DRAWN:	Pufei Wu	DATED:	2007.09.17	COMPANY:	Walasey Technology L.t.d				
CHECKED:	<Checked By>	DATED:	<Checked Date>	TITLE:	HTV270 LCD-TV				
QUALITY CONTROL:	<QC By>	DATED:	<QC Date>	SCALE:	<Scale>	SIZE:	A2	SHEET:	0F 6

DRAWN:	Pufei Wu	DATED:	2007.09.17	COMPANY: Walasey Technology L.t.d		
CHECKED:	<Checked By>	DATED:	<Checked Date>	TITLE: HTV270 LCD-TV		
QUALITY CONTROL:	<QC By>	DATED:	<QC Date>	SCALE: <Scale>	SIZE: A2	SHEET: 6F 6

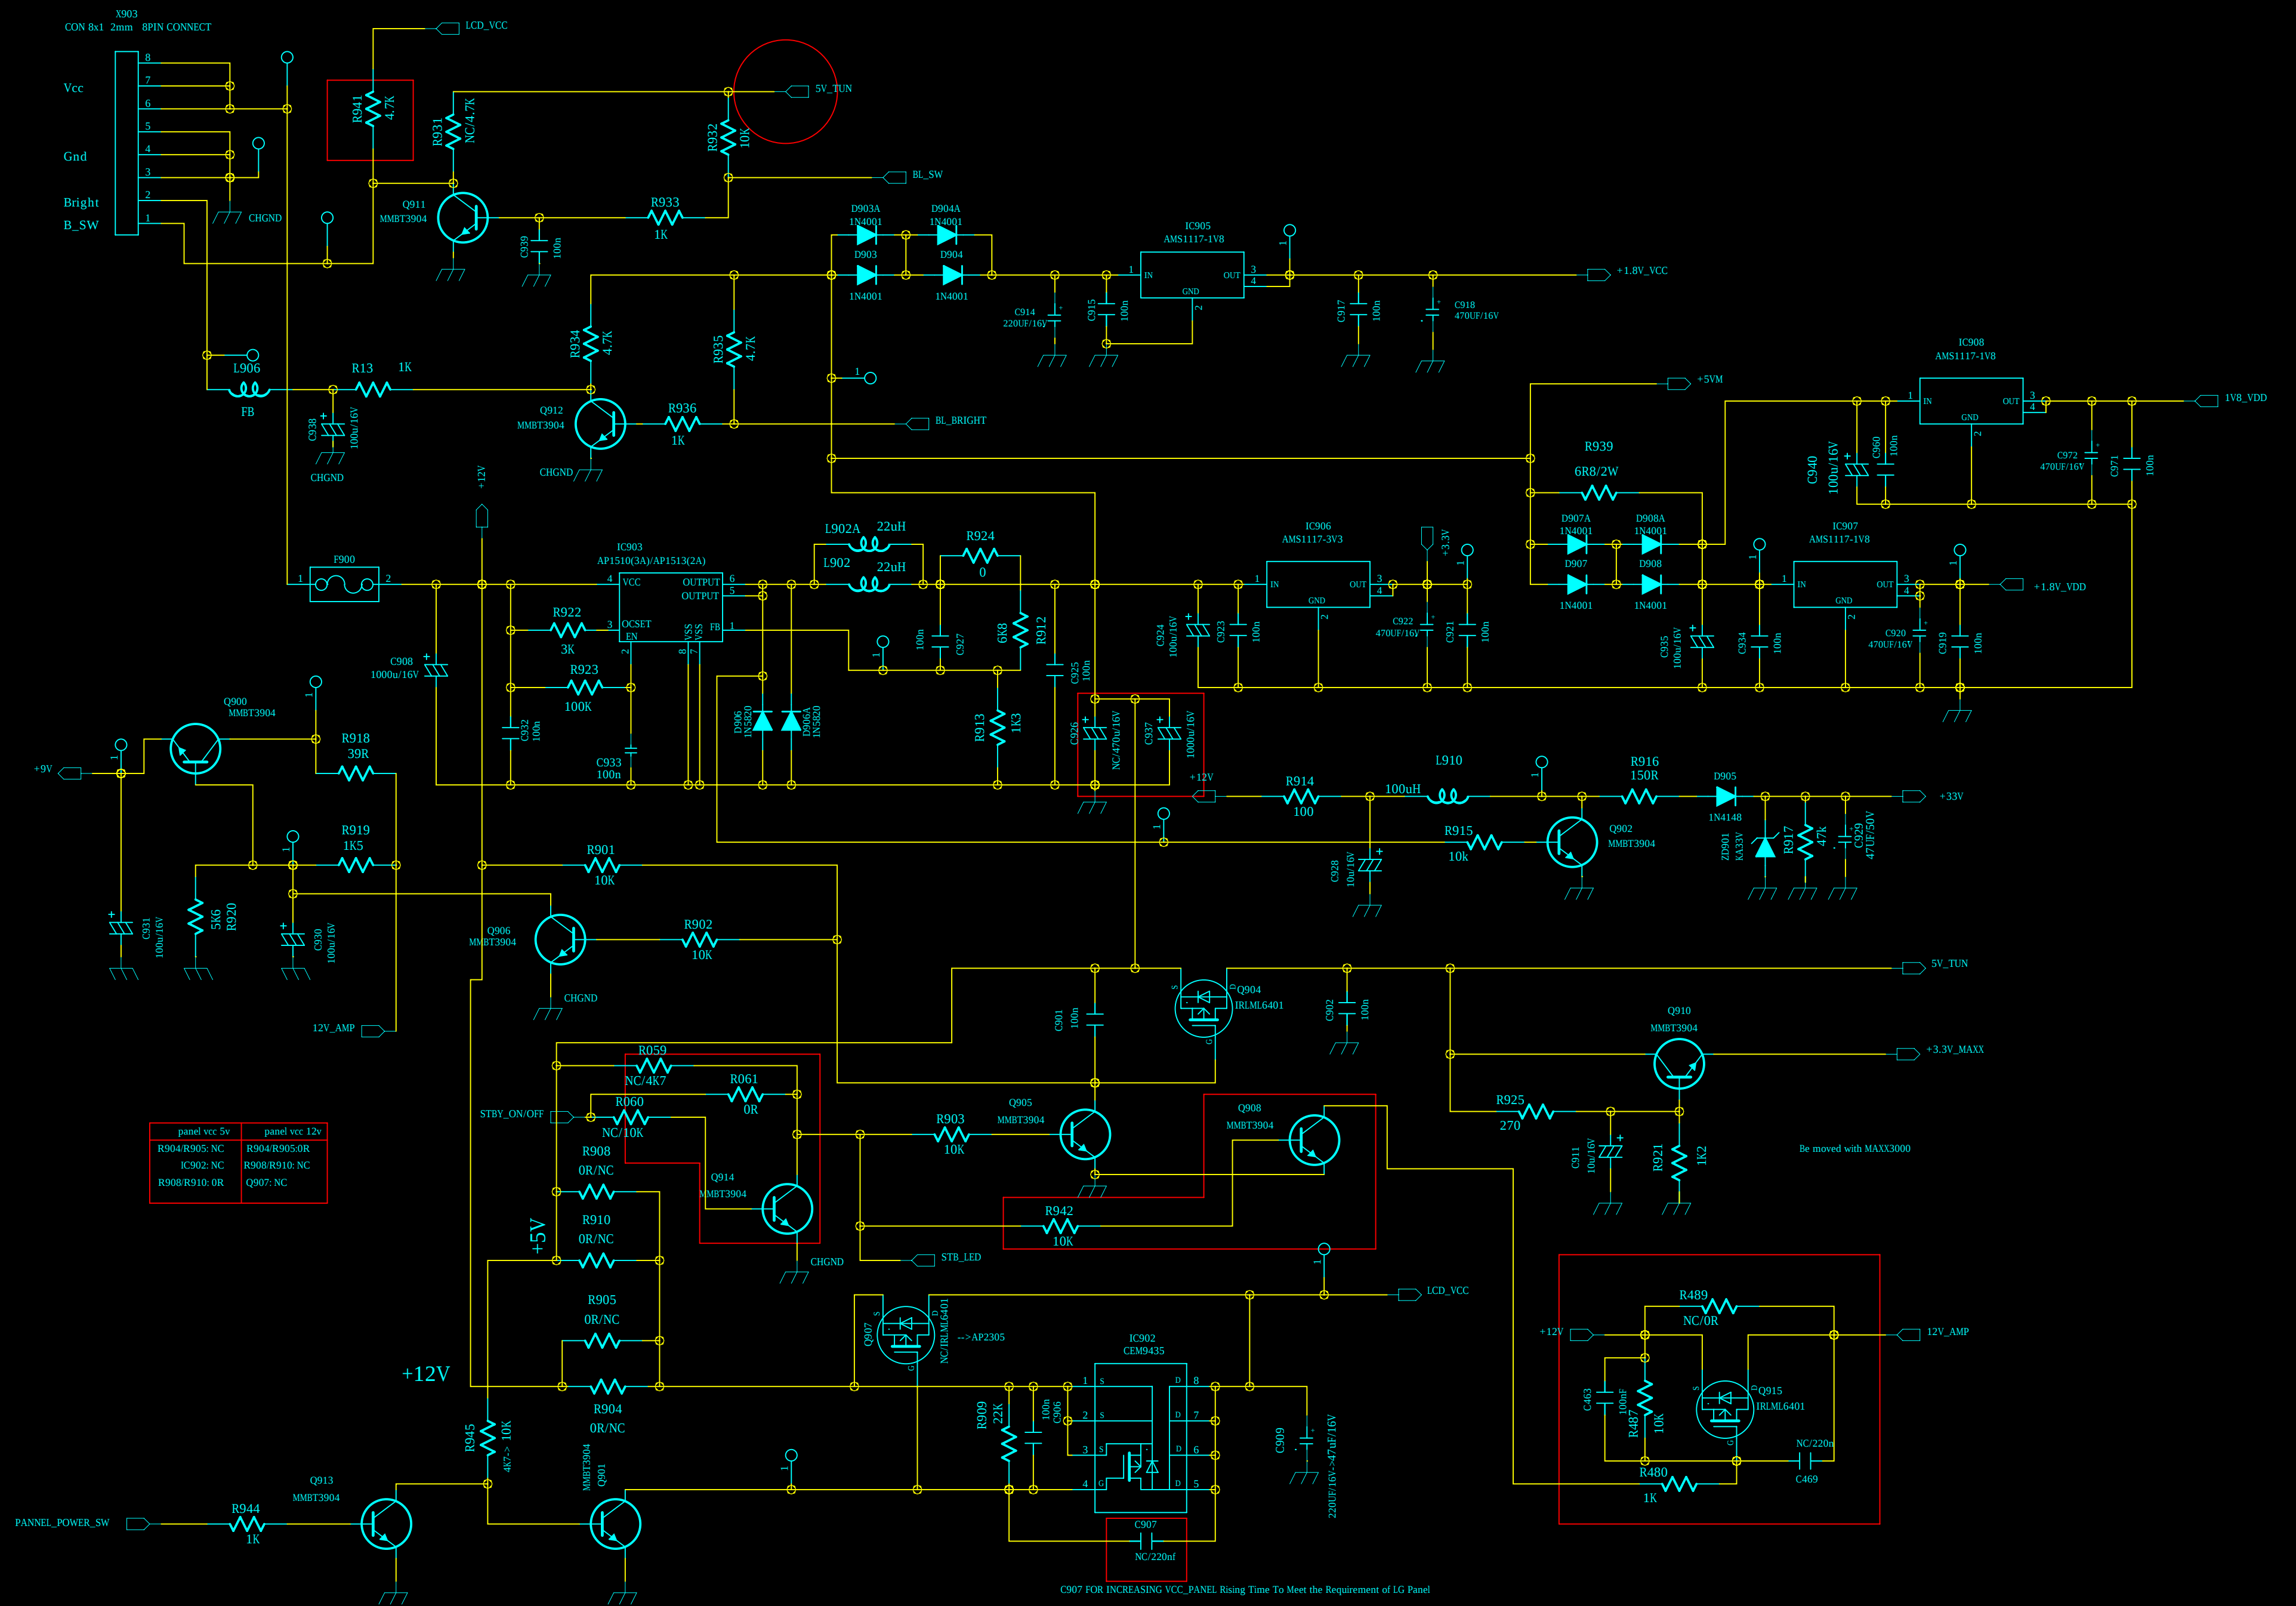
- 2008.3.4
Add C001/R037
Change BL_SW PIN
R467~R471-> Delete
J404/ZD451/Q441-> Delete
C444/C445/C463/C457/C458-> Delete
C456 470n-> 100n
R444 1K-> 2K7
R445 100K-> 10K
R464 -> 10K
R465 -> 3K3
R466 -> 100
- 2008.2.26
R413/R414->2K7
C413/C415->5600P
- 2008.2.28
C314-> Delete
R427~429-> 91K
R430/431/433-> 91K
